<b>marantz®</b>  <b>SERVICE BULLETIN</b>		Date: 15-May.-2003	Model: PM4200
		Page: 1 / 1	REF.NBR: MZ03-012
Circulation:	Application:	Subject: The unit works by the remote controller of other company.	
x for information customer complaint in case of service mandatory .....	See Below		
		Int.ref:

<div><b>marantz®</b></div> <div>SERVICE BULLETIN</div>		Date: 17-Jul.-2002	Model: PM4200
		Page: 1/2	REF.NBR: MZ02-009revision
		Subject: Problem with incorrect operation of MUTE.	
Circulation:	Application:		
x for information customer complaint in case of service mandatory .....	See below		
		Int.ref:

### Processing figure (Part side view)

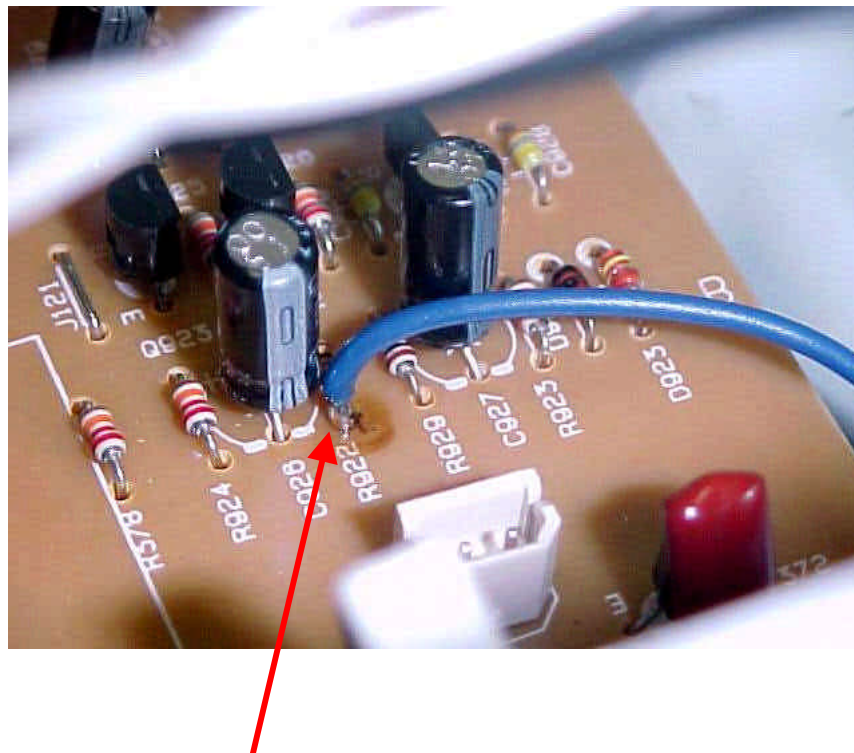
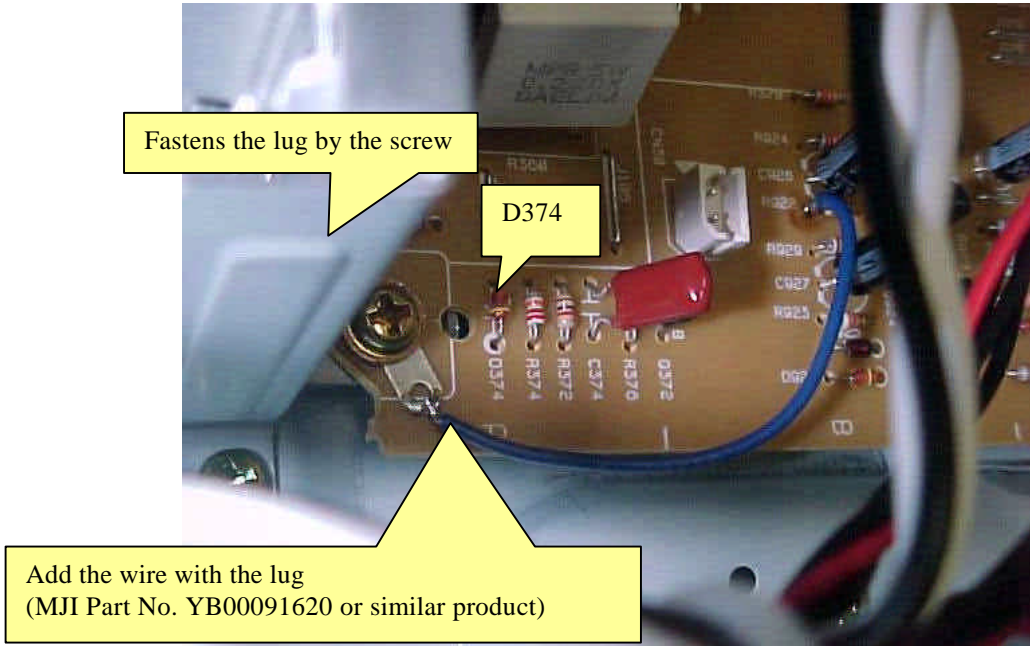
The MUTE LED sometimes blinks and the sounds from output intermit.

Contact error between the bracket (Pos. No. 30) and the ground of INPUT/AMPLIFIER PCB (Pos. No. 29).

Contact to the ground certainly by the wire with the lug.

**Solder the wire to the ground side lead of the R922 or R929**
